GRPE Session 13-16 jan 2009

GFV Group

Regulation No. 115 changes

Figure 1
NON-INTRUSIVE RETROFIT SYSTEM APPROVAL – FLOW CHART

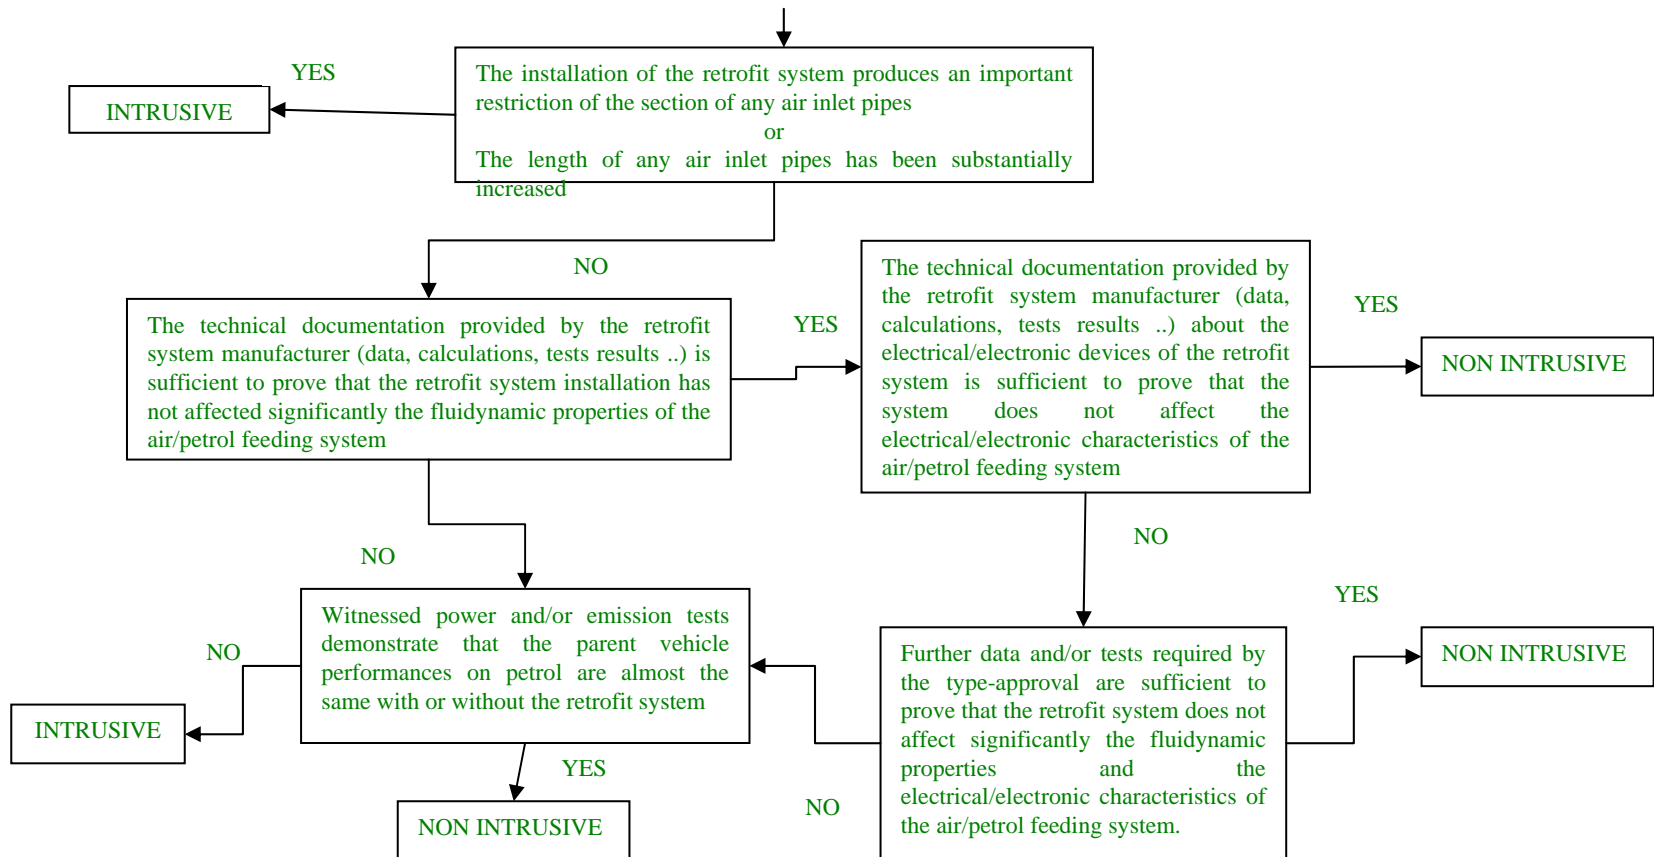
6.1.2.2 In order to prove that the retrofit system is "non intrusive", as defined in paragraph 2.1.5., the system manufacturer shall provide data and/or engineering evaluations which adequately demonstrate that the performance of original air and petrol feed system to the engine are not affected by the installation of the retrofit system. For the approval of a retrofit system as “non-intrusive”, the flow chart provided in figure 1 shall apply.

AEGPL is firmly convinced that the “non-intrusive” concept should be kept because there are systems that, by design, do not affect the original emission performance of the cars.

However, in order to prevent any misinterpretation and to ensure an harmonized approach by all TAA, AEGPL proposes to improve the non-intrusivity definition and, hence, the related characterization assessment.

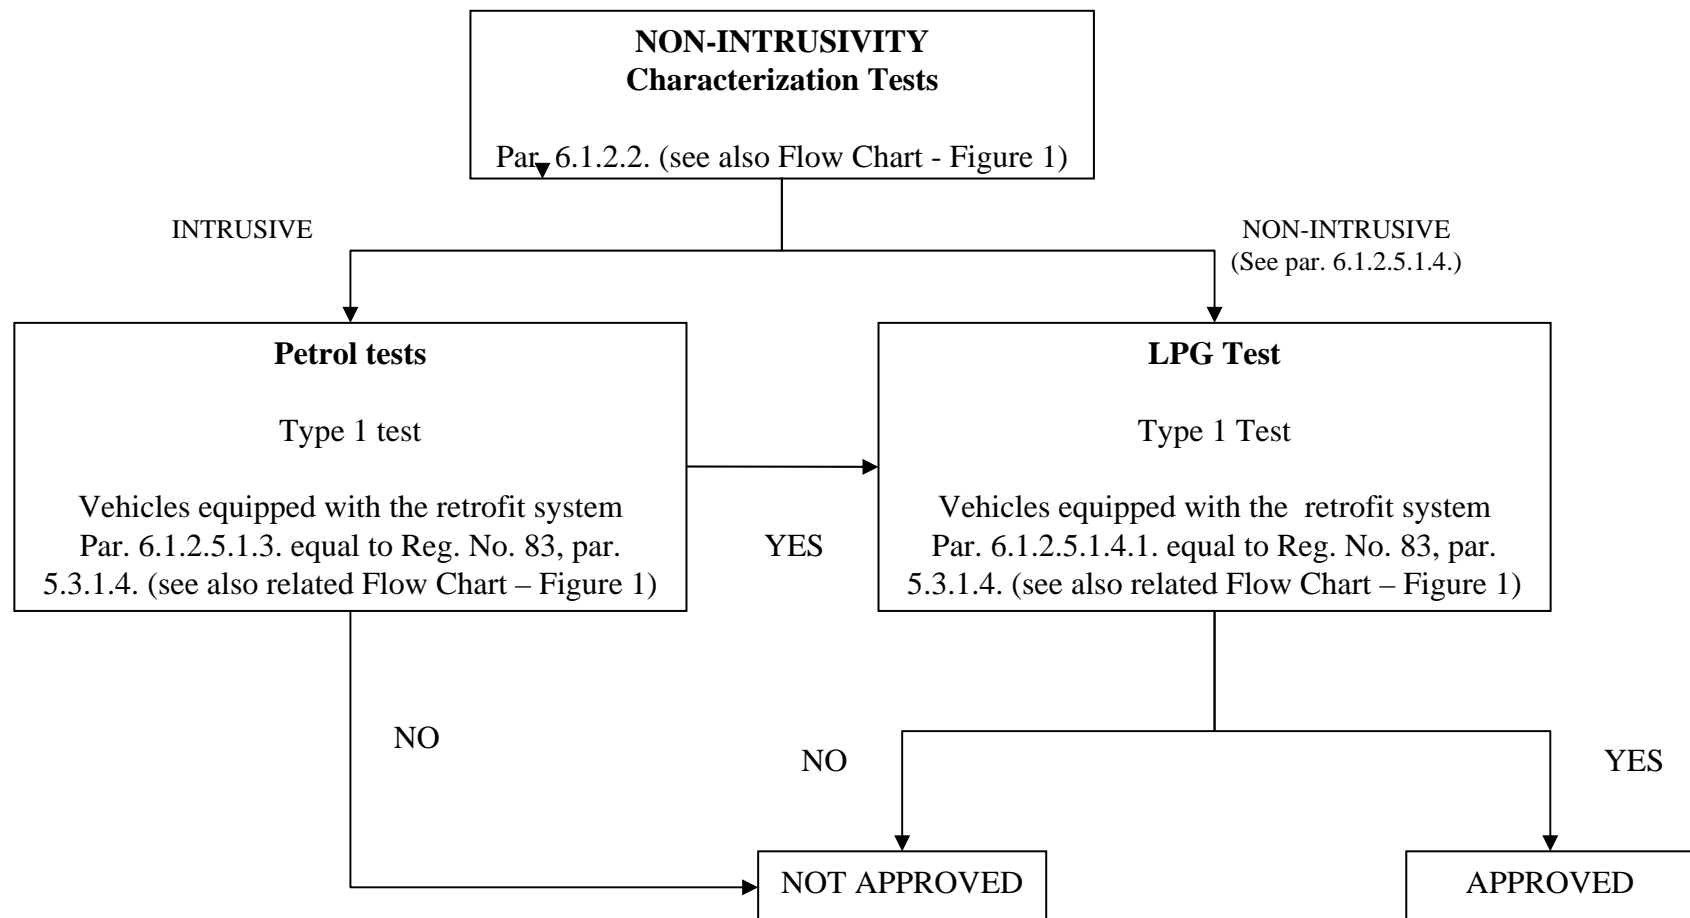
6.1.2.5.1.4.2. Notwithstanding the requirements of paragraph 6.1.2.5.1.4.3., for each pollutant or combination of pollutants, one of the three test results may exceed, by not more than 10 per cent, the limit prescribed, provided the arithmetical mean of the three results is below the prescribed limit. Where the prescribed limits are exceeded for more than one pollutant, it is immaterial whether this occurs in the same test or in different tests.

The proposal aims at ensuring an alignment of the present procedure with the procedure of par. 5.3.1.4. of Regulation No. 83, 05 series of amendments. (see also justification to par. 6.1.2.5.1.5.)
